**CITY OF SEATTLE
ANALYSIS AND DECISION OF THE DIRECTOR
OF THE DEPARTMENT OF PLANNING AND DEVELOPMENT**

Application Number: 3009098

Address of Proposal: 1400 N.W. Market St.

VIEW FROM SOUTHWEST LOOKING AT WEST FACADE

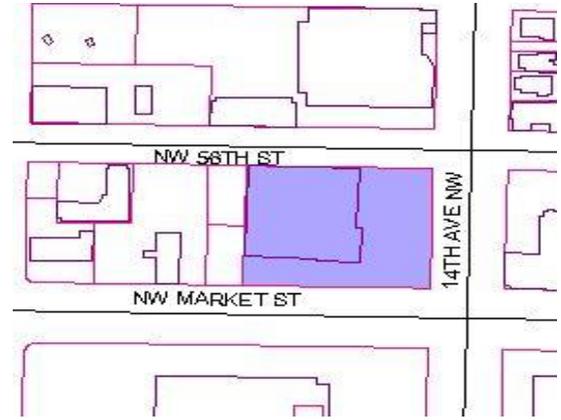
The two blank elements without setback from the property line in the west façade continue to need refinement. The pattern of contrasting shapes is not of the same scale as the rest of the building. It should be more subtle so that it is not the first thing you notice when viewing the building from the west. Yet the texture and pattern needs to be substantial enough to be recognizable from a distance. Without introducing a new color the gray tone of the concrete base could be brought into the upper pattern. Maybe less blue could be used. Maybe some horizontal lines could be incorporated into the pattern. This redesign can be worked out with DPD staff and incorporated into the finished MUP.

The design of the portions of the western wall which are not fenestrated was further developed and approved by DPD staff and that scheme is evidenced in the image below.
